Top View

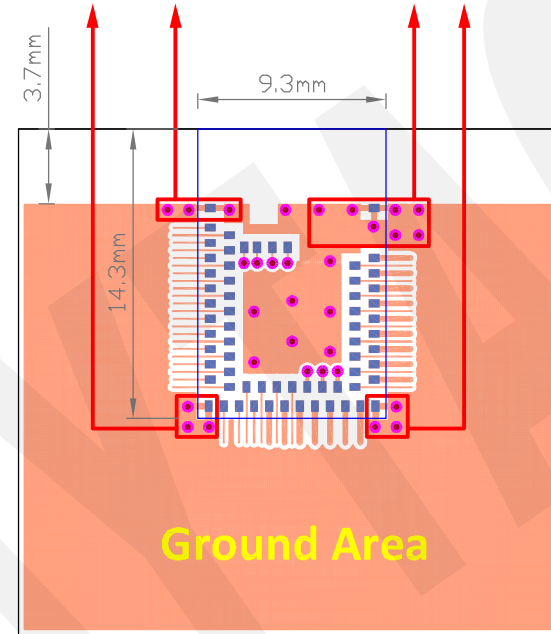
Please add via holes in GROUND area as many as possible, especially around the four corners.
